**CITY OF LEWISTON**  
**PLANNING BOARD MEETING**  
Monday, February 24, 2020 – 5:30 P.M.  
City Council Chambers – First Floor  
Lewiston City Building  
27 Pine Street, Lewiston, ME

TO: Lewiston Planning Board

RE: Dunkin Donuts Project at 420 Main Street

**SHEET 5**

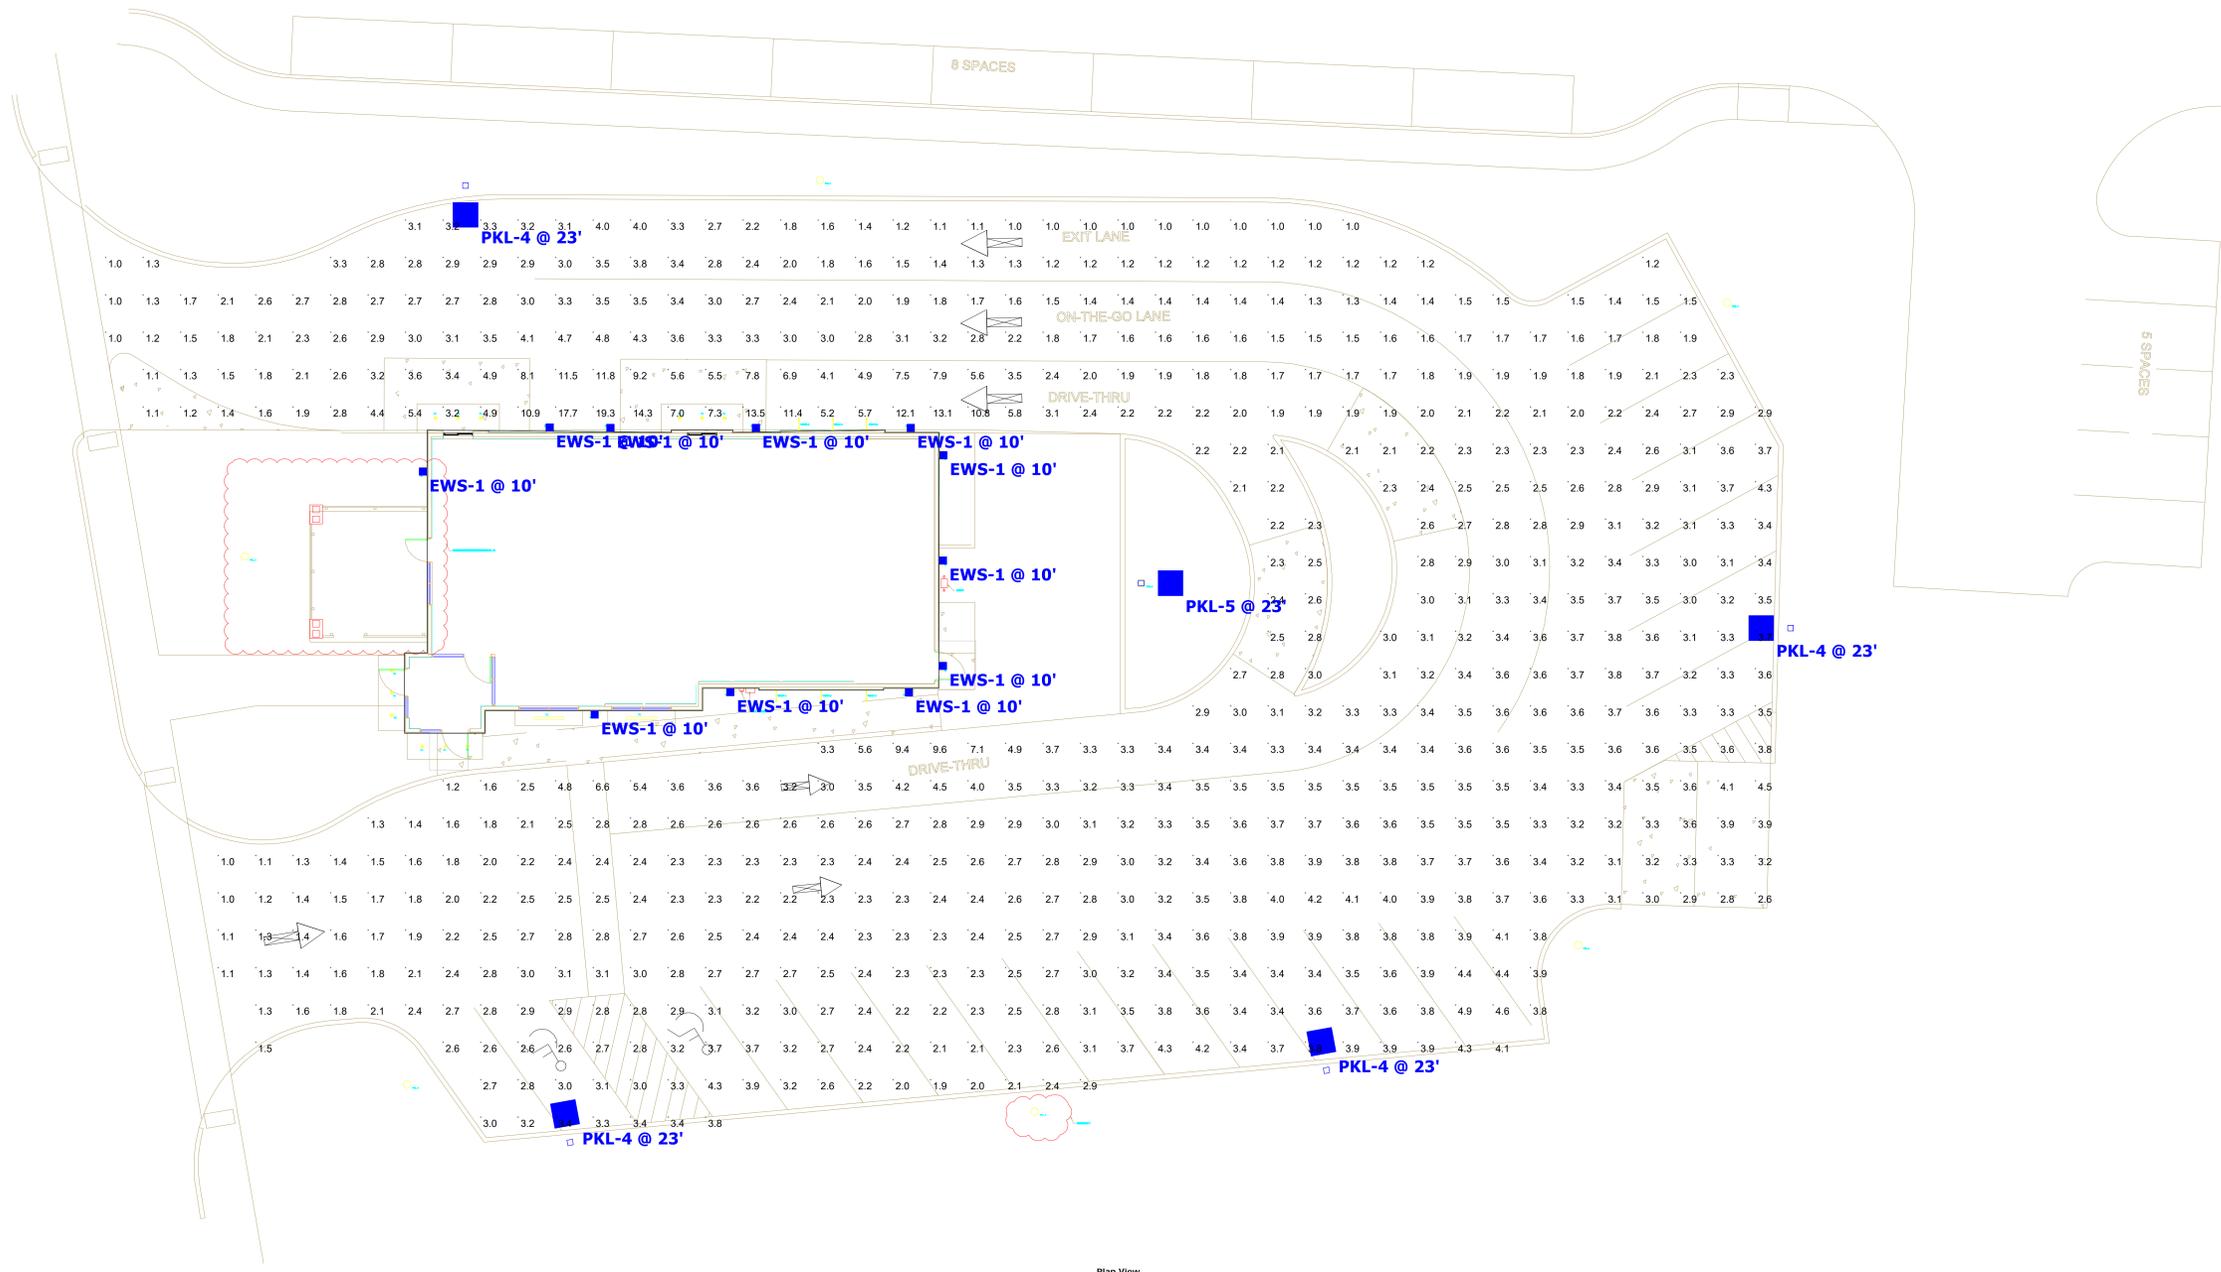
2. Please revise the crosswalk striping detail on sheet 5. City standards are a minimum width of 6-feet with a preferred width of 8-feet. The paint stripes consist of 24-inch wide stripes with a 24-inch space between
